METROPOLITAN AREA PLANNING
DEPARTMENT

Re: Administrative Adjustment 98-13: Administrative Adjustment to reduce the compatibility setback from 25 feet to 24 feet on the north side of the property.

Legal Description: Lot 14, 15, 16 and 17 Shreck's Addition.

Kay Plaza

Site Plan
1" = 20'-0"

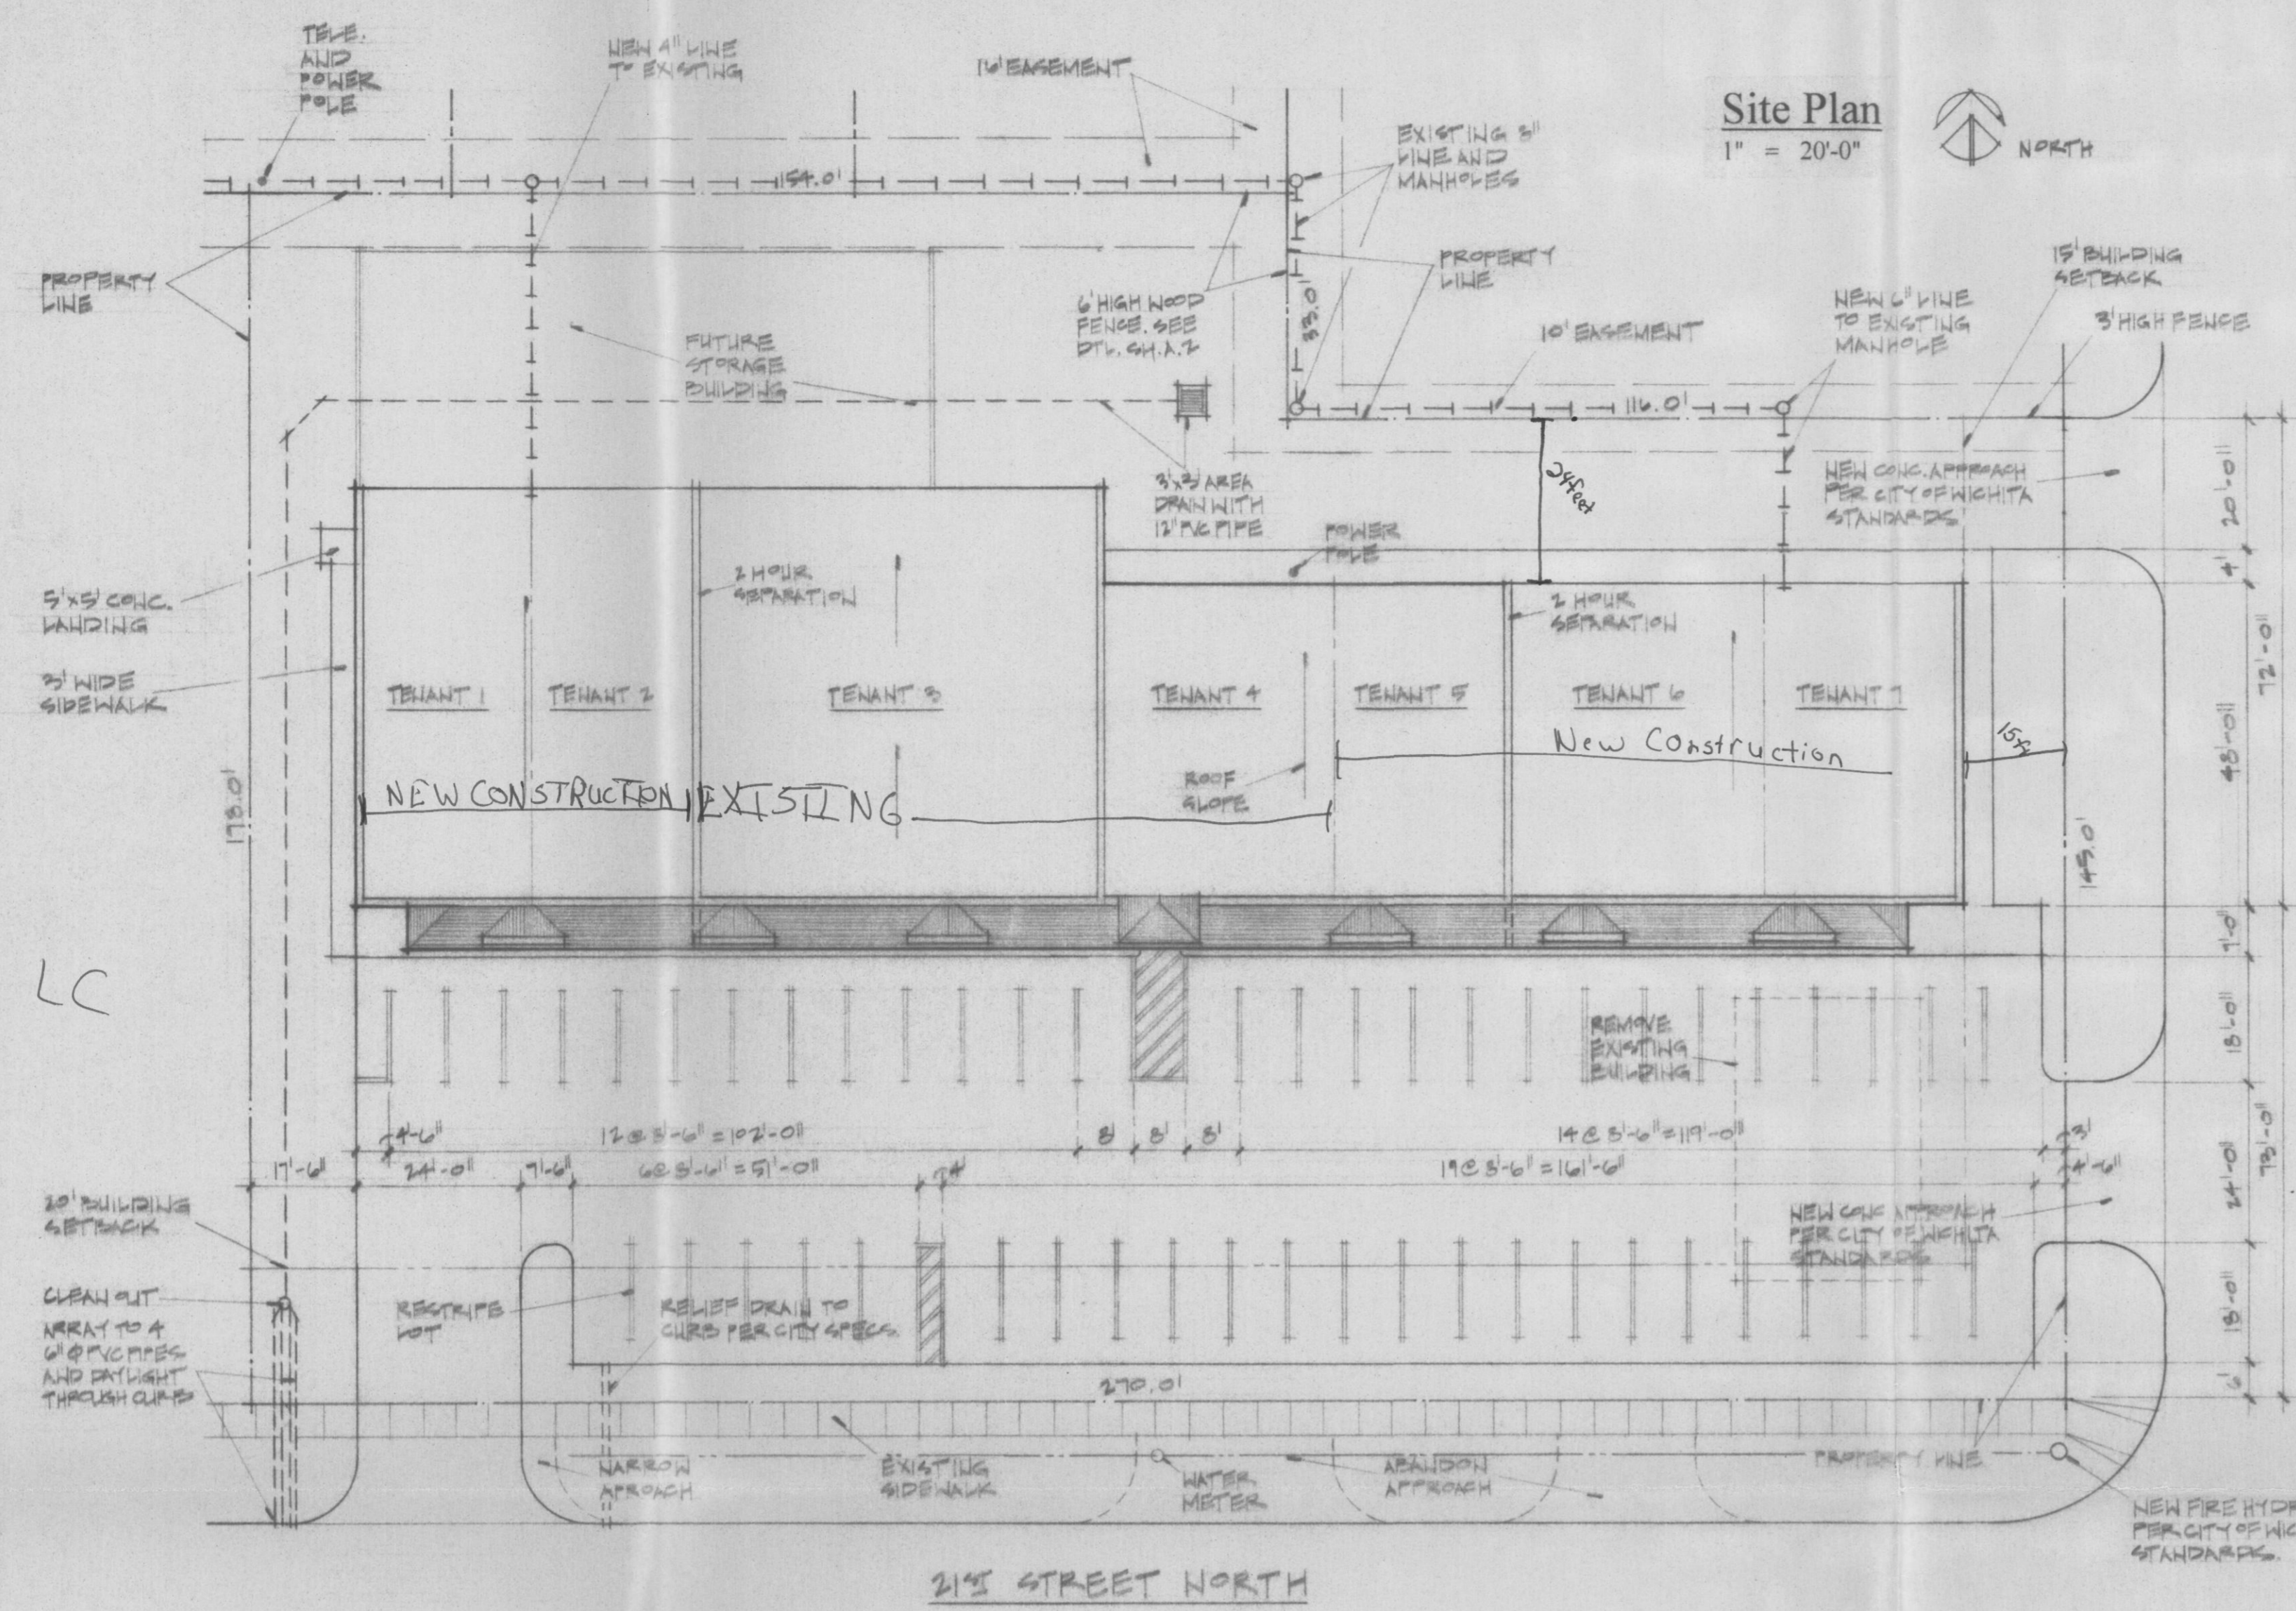
Our signatures below indicate that an administrative adjustment to reduce the compatibility setback from 25 feet to 24 feet is hereby granted subject to the following condition:

- 1) The applicant shall submit a revised landscape plan which meets the buffering requirement along the north property line. (A minimum of 8 trees)
- 2) The adjustment is only to reduce the compatibility setback from 25 feet to 24 feet for the buildings on the east portion of the property as shown on the attached site plan. This property should be developed in accordance with the site plan approved as part fo this adjustment.
